S4.55 MODIFICATION

S4.55 MODIFICATIONS	
Change ID	Name
Ch-01	Courtyard wall moved into courtyard
Ch-02	Alfresco deck reshaped
Ch-03	New window to first floor bathroom (W29)
Ch-04	Western wall on first floor moved forward by 650mm & balcony removed
Ch-05	New window to ground floor Dining (W20)
Ch-06	W04 - Kitchen window size change
Ch-07	Skylights relocated from stairwell to hallway
Ch-08	Eastern balcony screen reduced in length
Ch-09	Cellar footprint revised to include sauna

S4.55 MODIFICATION	
project	1130 PITTWATER RD
COLLARROY	
drawing	COVER SHEET
drawn SM / PC	checked MA
date 09.02.24	scale @ A3
project no 2_23_10	drawing no D0000
	issue D

drawing SITE PLAN

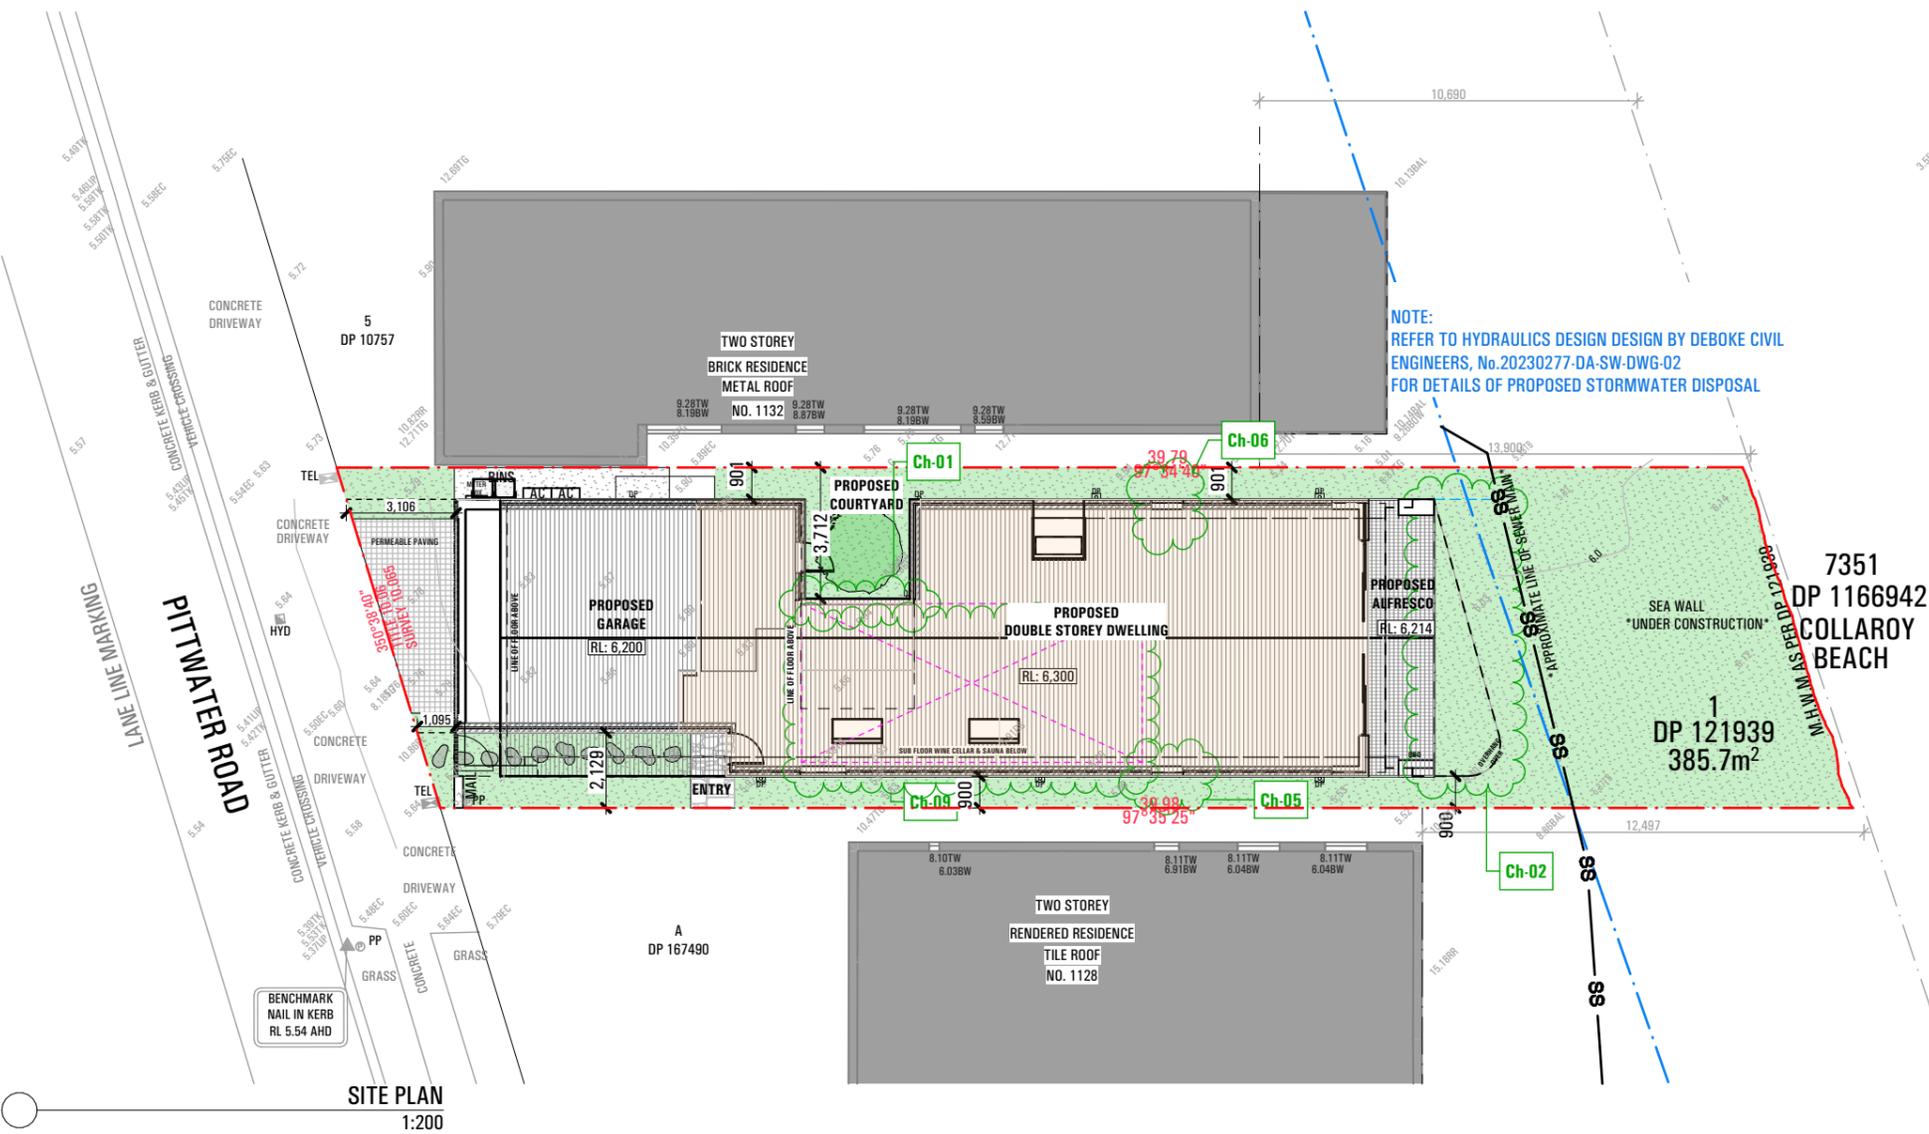
Change ID	Name
Ch-01	Courtyard wall moved into courtyard
Ch-02	Alfresco deck reshaped
Ch-03	New window to first floor bathroom (W29)
Ch-04	Western wall on first floor moved forward by 650mm & balcony removed
Ch-05	New window to ground floor Dining (W20)
Ch-06	W04 - Kitchen window size change
Ch-07	Skylights relocated from stairwell to hallway
Ch-08	Eastern balcony screen reduced in length
Ch-09	Cellar footprint revised to include sauna

S4.55 MODIFICATION	
project	1130 PITTWATER RD
COLLARROY	
drawing	
GROUND FLOOR PLAN	
drawn SM / PC	checked MA
date 09.02.24	scale @ A3
project no 2_23_10	drawing no D2100
issue	D

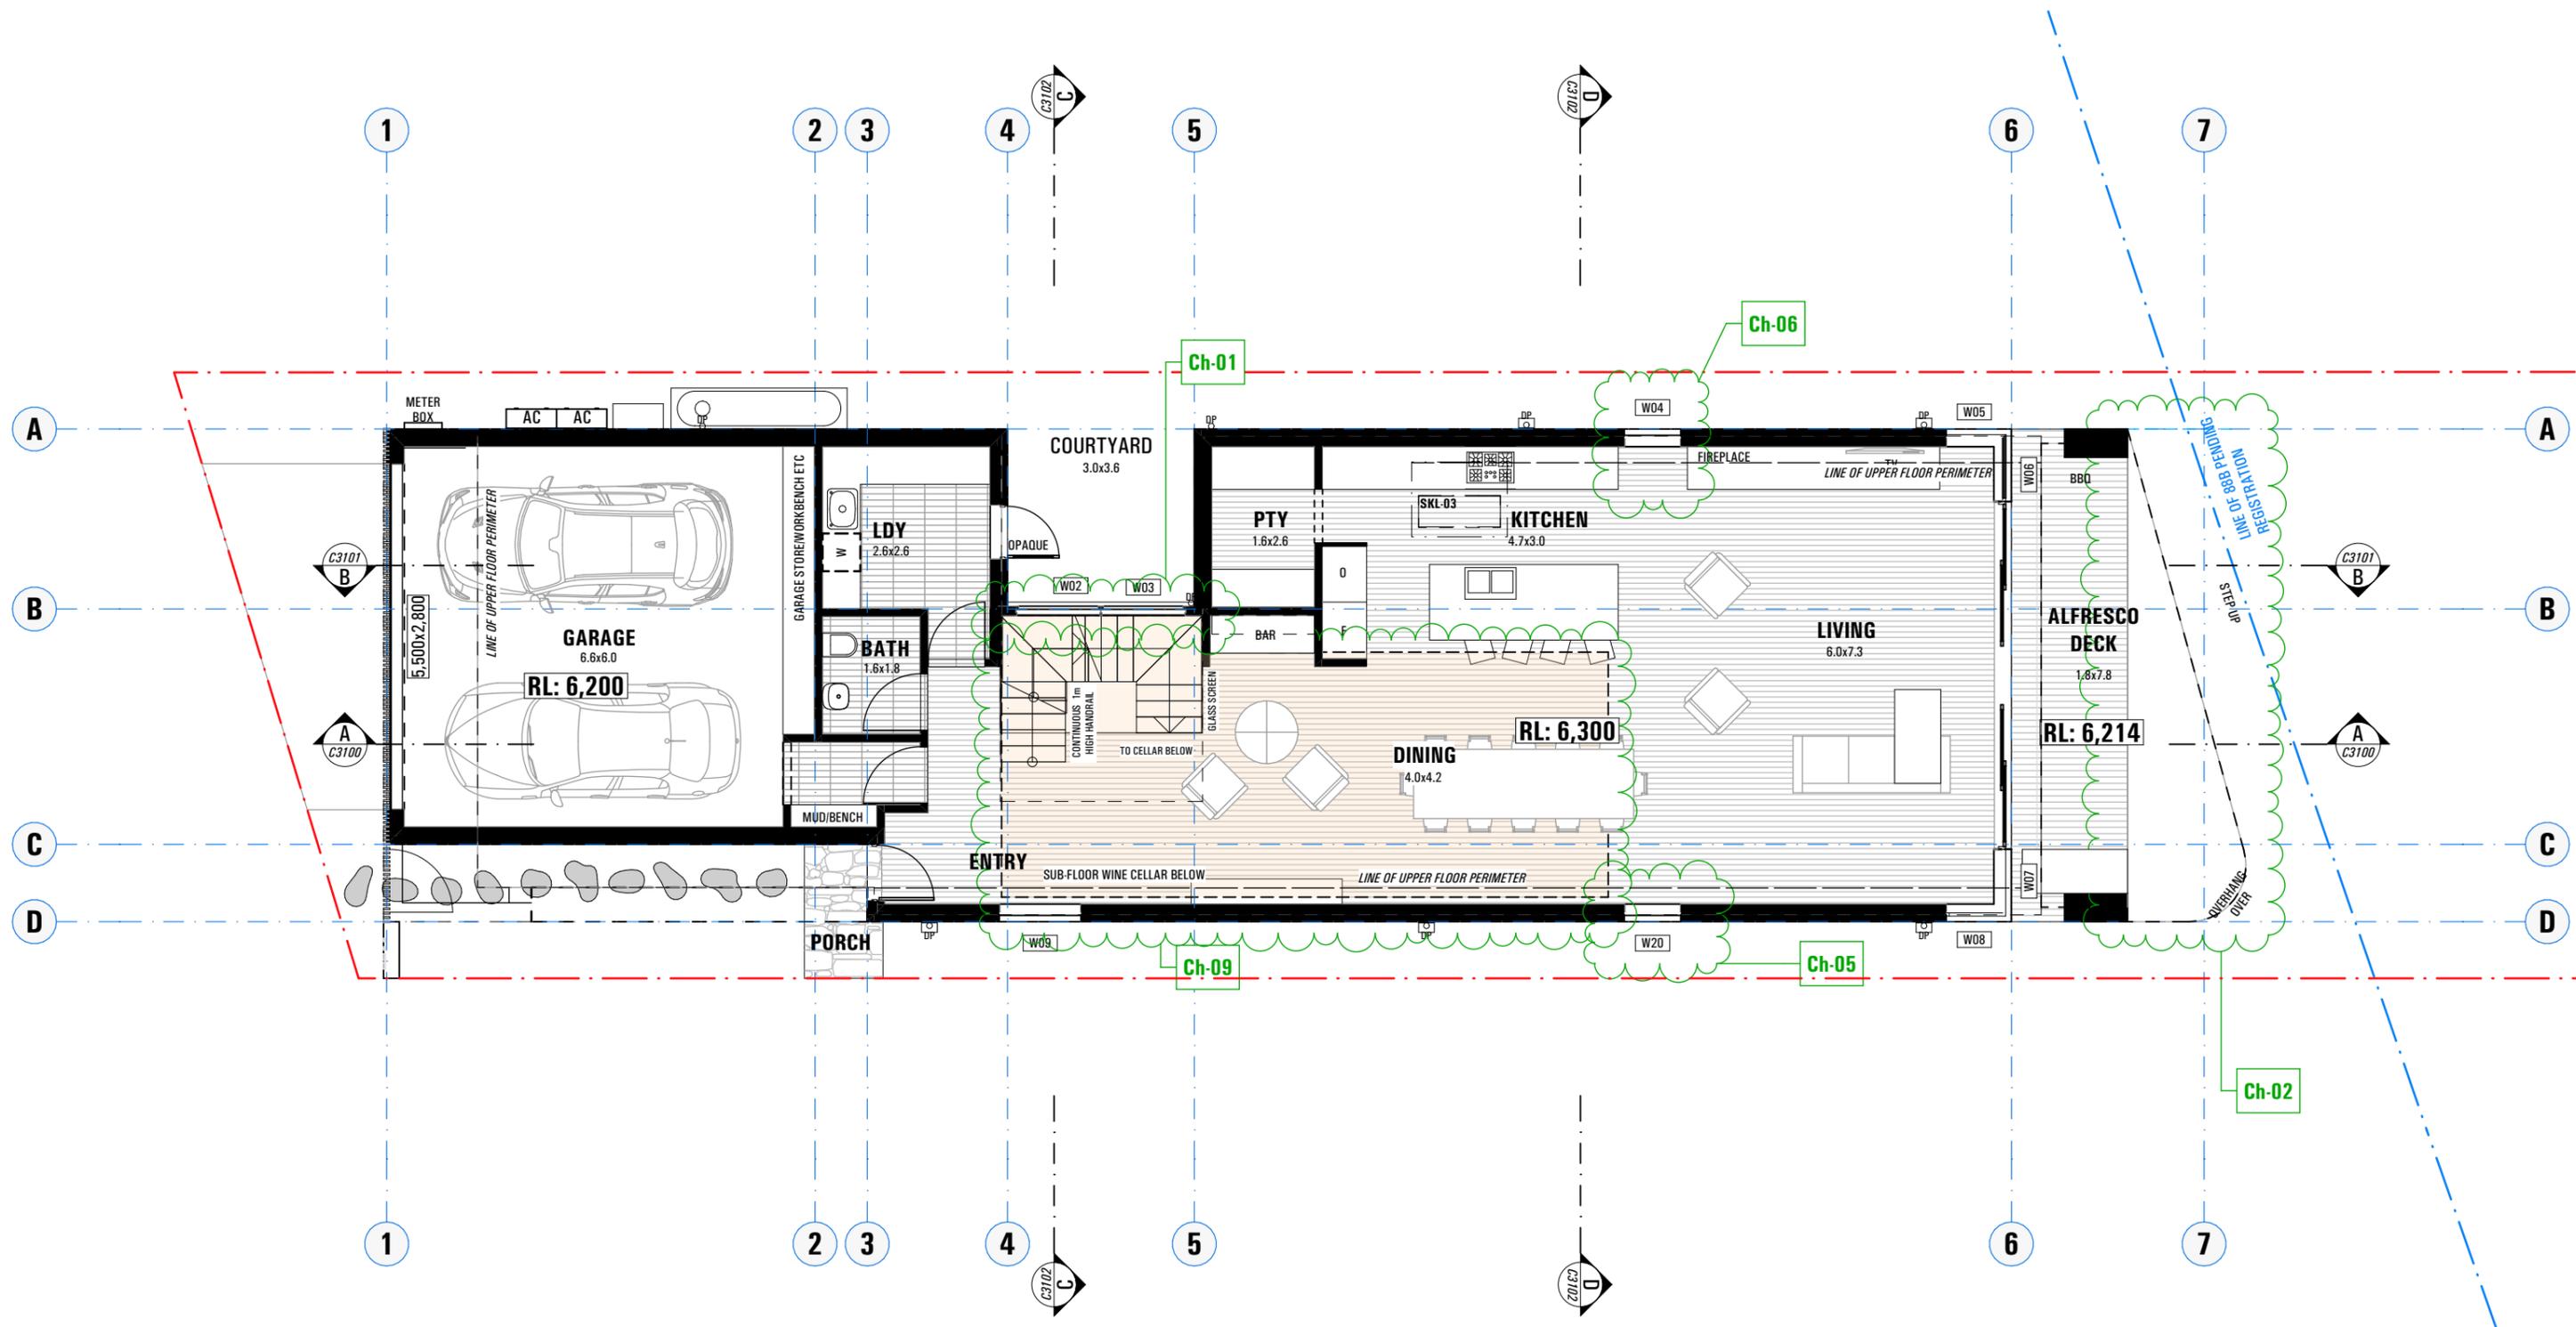
S4.55 MODIFICATIONS	
Change ID	Name
Ch-01	Courtyard wall moved into courtyard
Ch-02	Alfresco deck reshaped
Ch-03	New window to first floor bathroom (W29)
Ch-04	Western wall on first floor moved forward by 650mm & balcony removed
Ch-05	New window to ground floor Dining (W20)
Ch-06	W04 - Kitchen window size change
Ch-07	Skylights relocated from stairwell to hallway
Ch-08	Eastern balcony screen reduced in length
Ch-09	Cellar footprint revised to include sauna

S4.55 MODIFICATION	
project	1130 PITTWATER RD
drawing	
checked MA	
date	09.02.24
scale	@ A3
project no	2_23_10
drawing no	D2101
issue	D

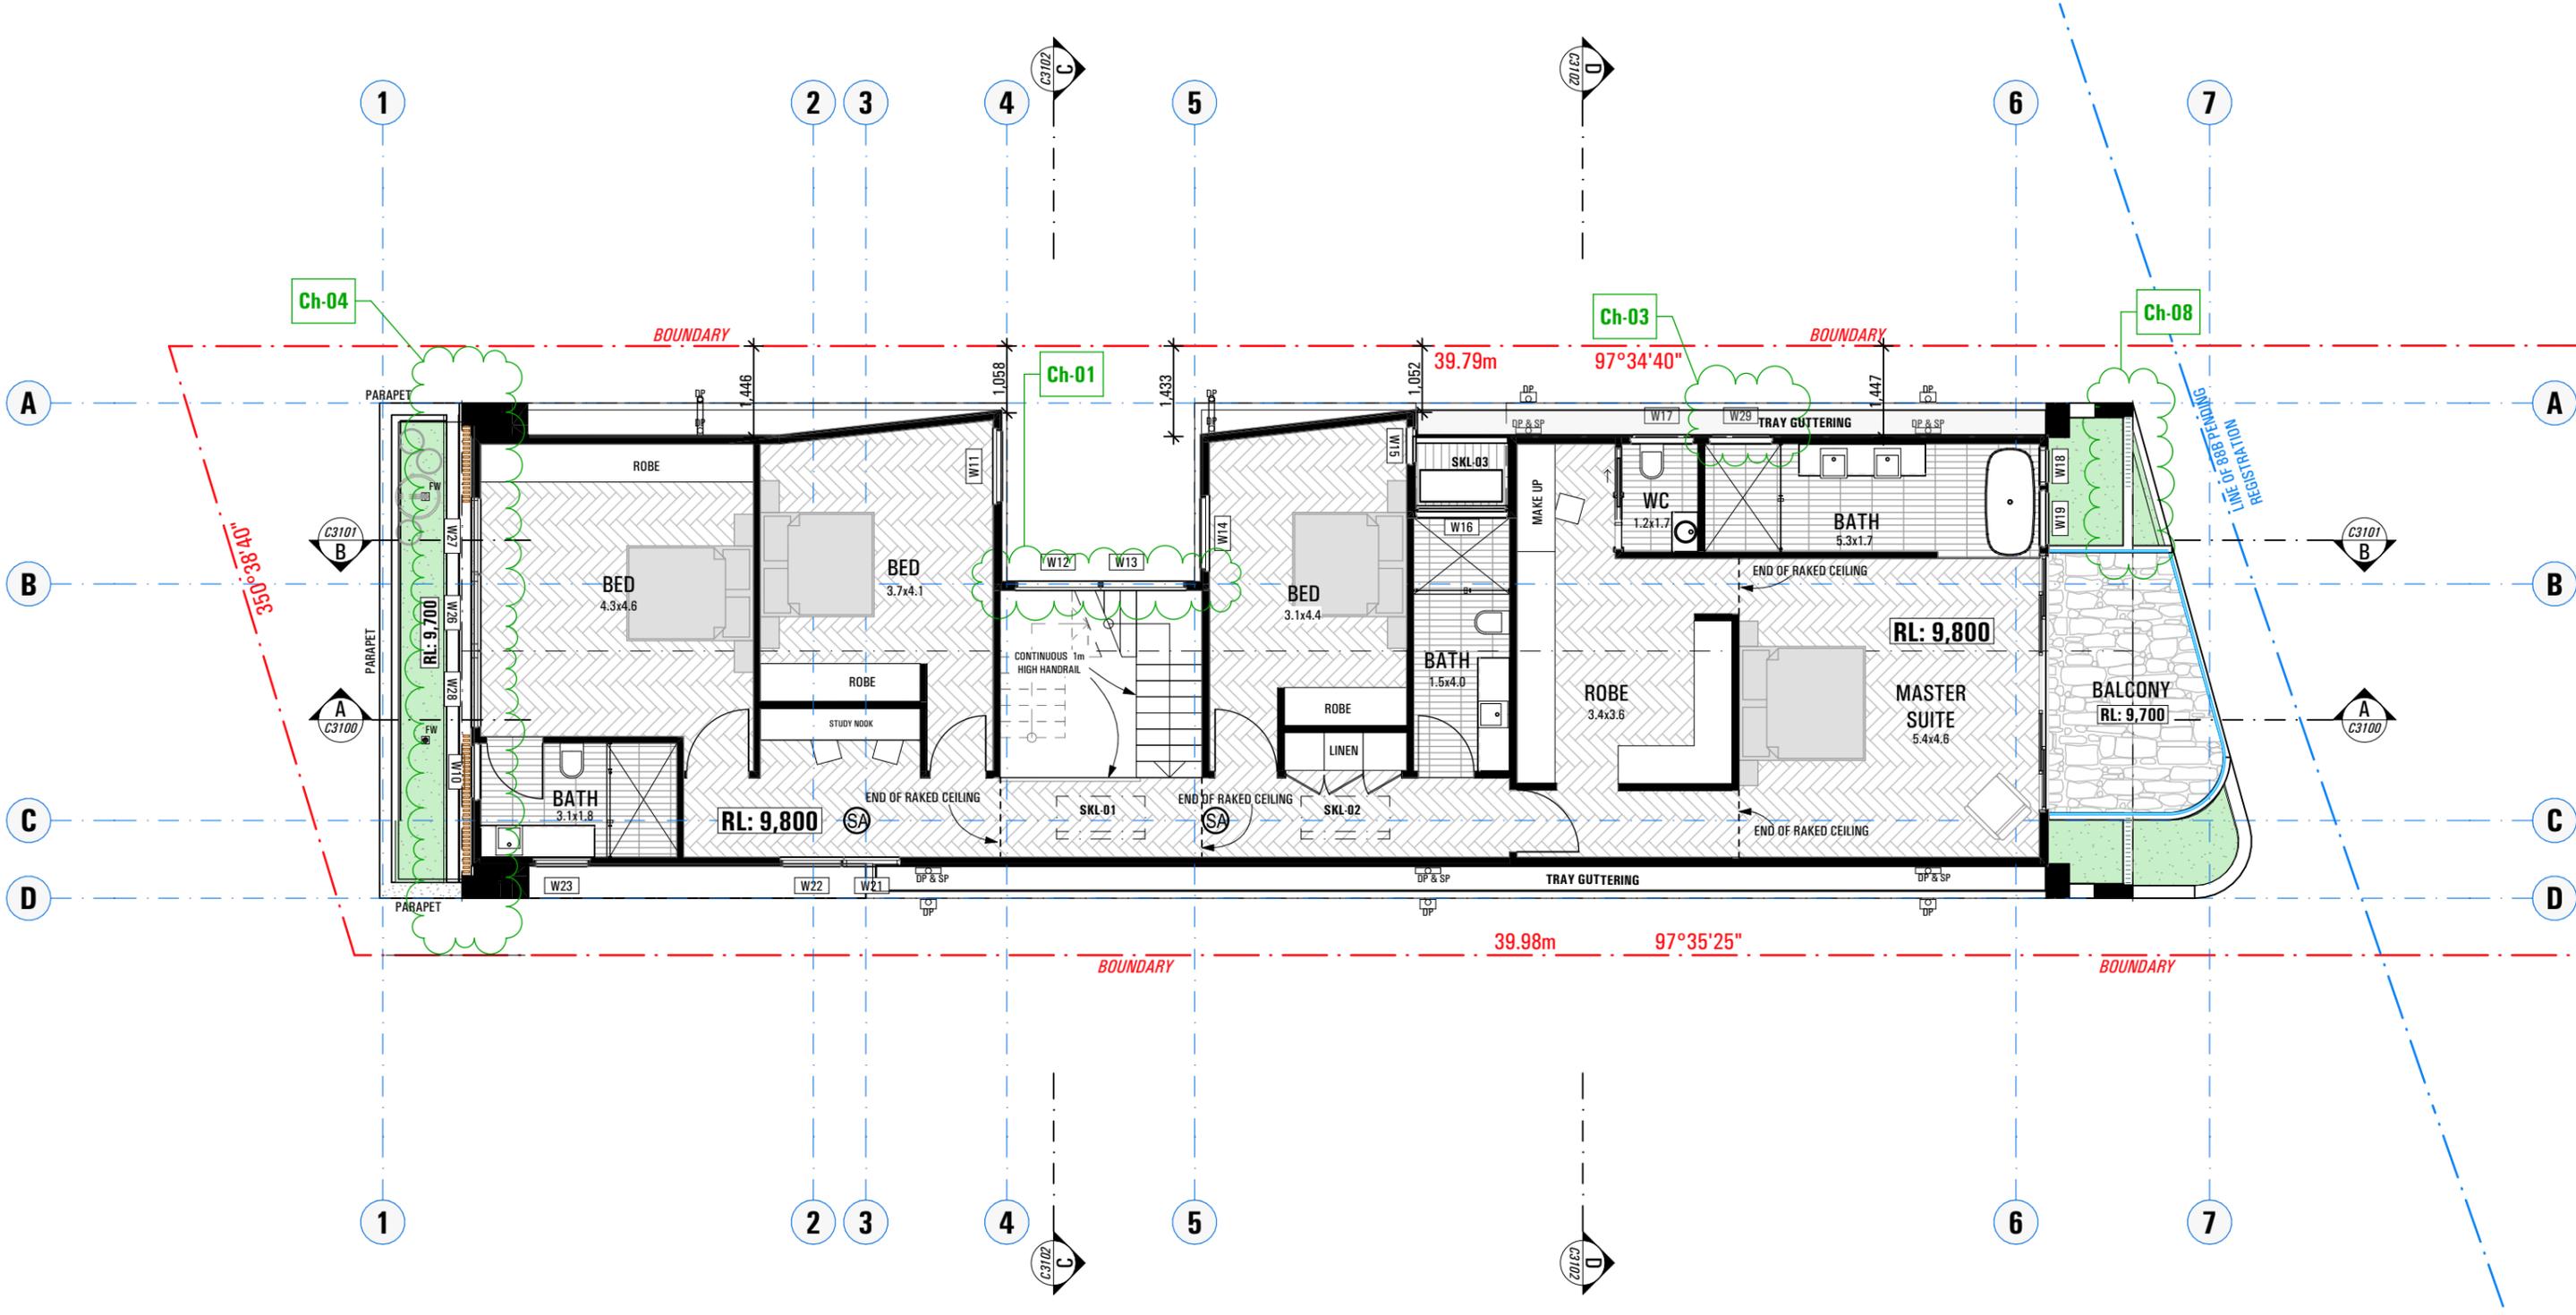
S4.55 MODIFICATIONS	
Change ID	Name
Ch-01	Courtyard wall moved into courtyard
Ch-02	Alfresco deck reshaped
Ch-03	New window to first floor bathroom (W29)
Ch-04	Western wall on first floor moved forward by 650mm & balcony removed
Ch-05	New window to ground floor Dining (W20)
Ch-06	W04 - Kitchen window size change
Ch-07	Skylights relocated from stairwell to hallway
Ch-08	Eastern balcony screen reduced in length
Ch-09	Cellar footprint revised to include sauna
